INNER WEST COUNCIL

DEVELOPMENT ASSESSMENT REPORT

Application No.	M/2018/5
Address	6 Montague Street, BALMAIN NSW 2041
Proposal	Section 4.55 modification to approved flat building including additional first floor terrace to unit 4 on the northern elevation and internal layout changes to unit 4
Date of Lodgement	18 January 2018
Applicant	Blue Bridge Property Pty Ltd
Owner	Blue Bridge Property Pty Ltd
Number of Submissions	Nil
Reason for determination at Planning Panel	Demolition works to a heritage item
Main Issues	Demolition works to a heritage item
Recommendation	Approval
Attachment A	Recommended conditions of consent
Attachment B	Plans of proposed development

View of roof monitor from Little Darling Street

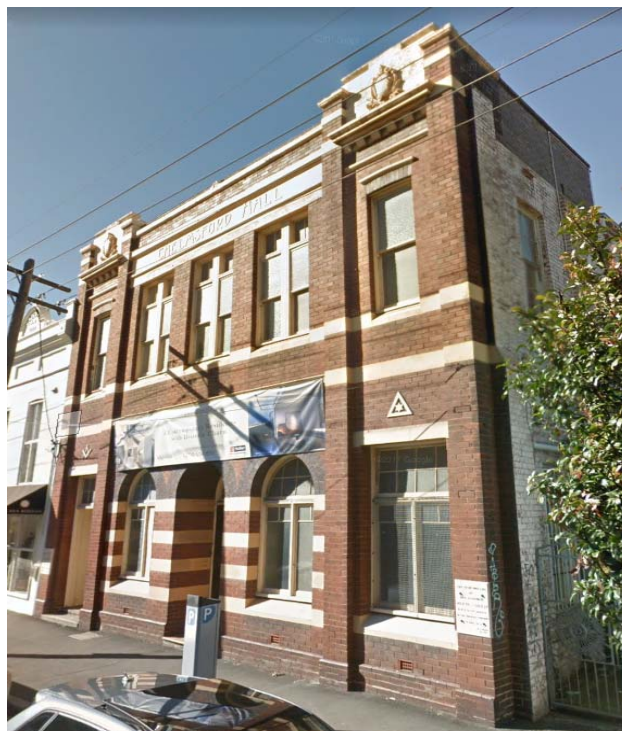
Extending the glazing of the roof monitor windows in Apartment Four to form doors would result in the removal of the pressed metal sheeting in this area. Rather than remove the sheeting in its entirety, a design should be developed that incorporates the pressed metal into the lower section of a set of doors. When closed, the same relationship between the window glazing and spandrel panel will remain evident from within the apartment.

The revised drawings show fully glazed French Doors whereas the aim was to salvage the pressed metal wall panels and utilised these as a panel in the French doors.

- b) The French Doors to the roof balcony in Apartment 4 are to be constructed of timber and the pressed metal panels currently in this location are to be salvaged and incorporated as a panel in the lower portion of each door leaf, to the height of the existing windows. When closed the same relationship between the window glazing and panel below will remain evident from within the apartment. Externally the French Doors are to have a timber panel, like a traditional French door.

PROJECT NAME	SECTION APT 4 - POS S9g modifications
DATE	Revision 14
SCALE	1: 10 @ A1 1: 20 @ A3
DATE	02.09.2018
PROJECT ARCHITECT	MIKE MACALJAY
ARCHITECT FIRM	BLUE BRIDGE PROPERTY LIMITED
PROJECT NO.	SB6 100 - 14

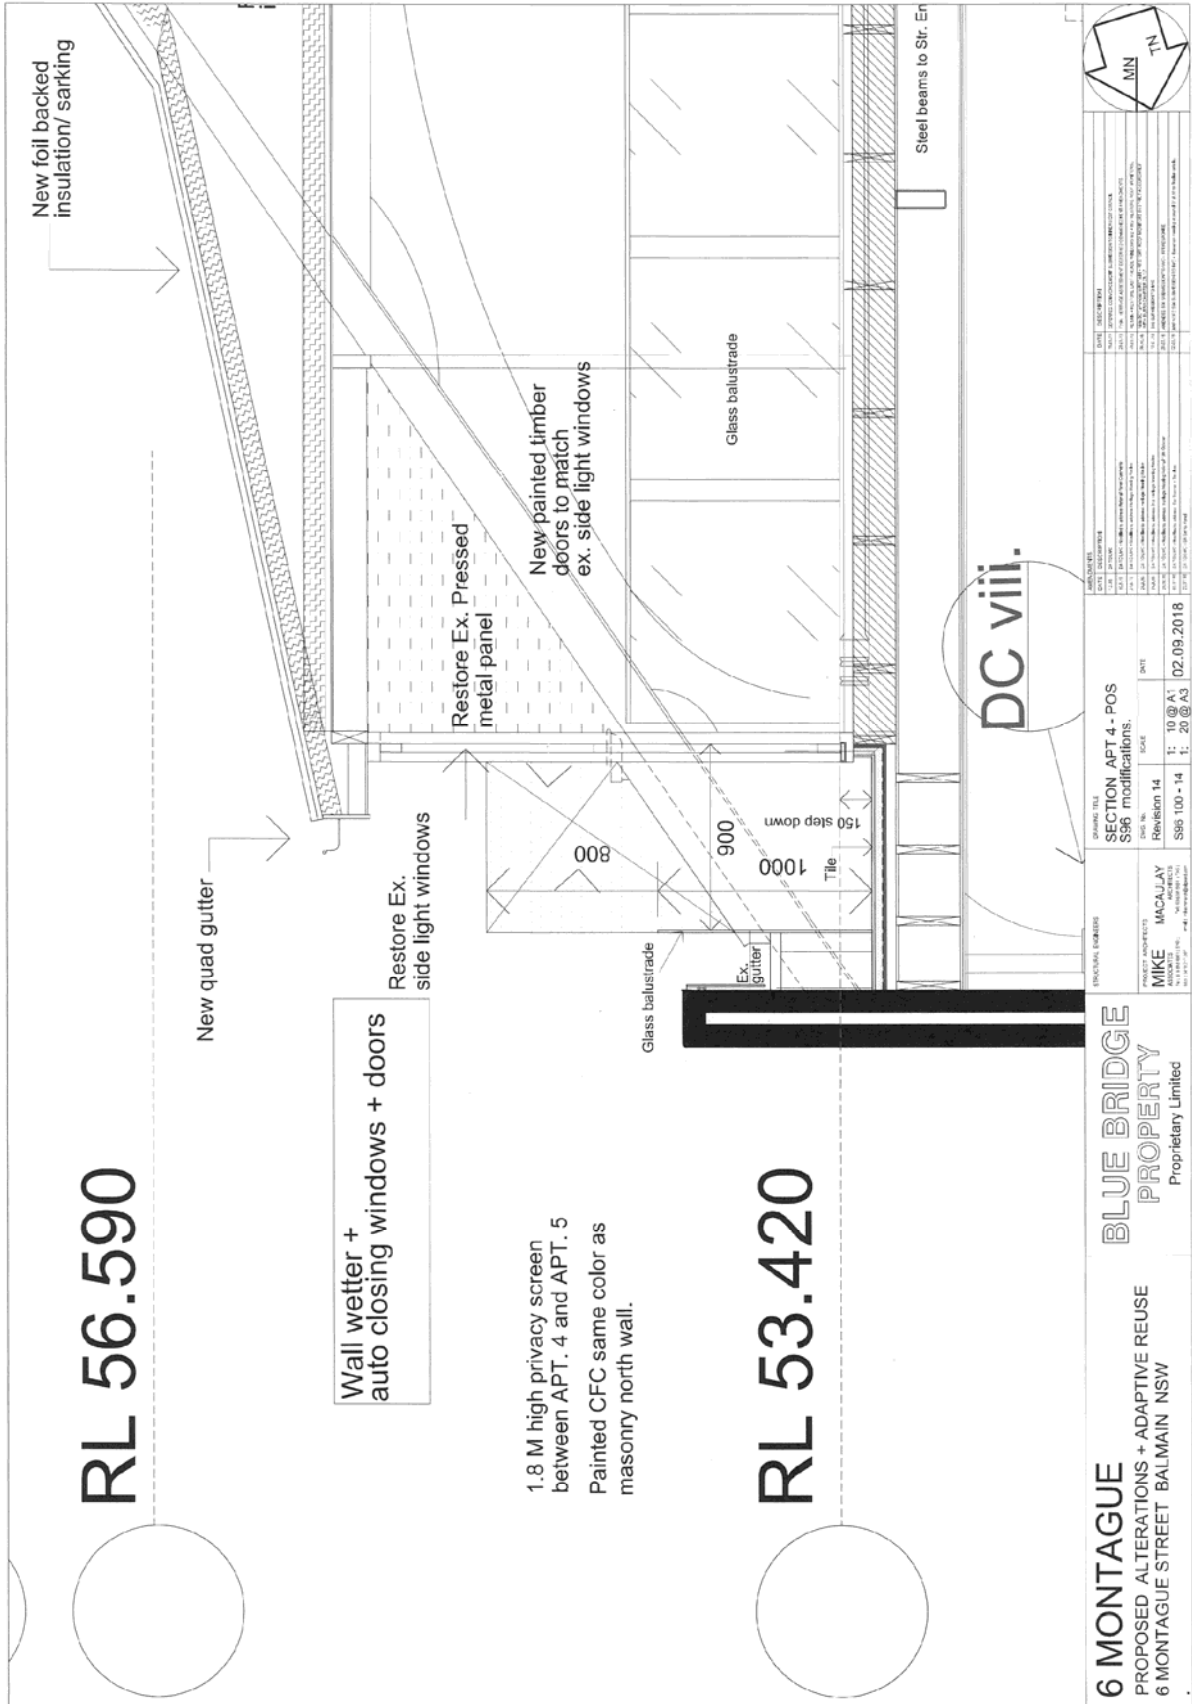
The proposed balcony to apartment 4 only proposes a privacy screen on its eastern elevation to provide privacy between apartment 4 and apartment 5. No privacy screen is proposed on the western elevation of the apartment 4 balcony between the private open space of apartment 3 and 4, however the plans indicate that a privacy screen is proposed on the eastern elevation of the terrace/balcony of apartment 3 to provide adequate privacy screening.

Given that no elevational plan of the privacy screen to apartment 3 appears to have been provided, a condition is recommended requiring privacy screening to the eastern elevations of the terrace/balconies of apartments 3 and 4.

- a) Privacy screens are to be erected on the eastern elevations of the first floor mezzanine level terrace/balconies of apartments 3 and 4. The privacy screens shall have a minimum height of 1.6m as measured from finished balcony level; have no individual opening more than 30mm wide; have a total area of all openings that is less than 25 per cent of the surface area of the screen; and be permanently fixed and made of durable materials.
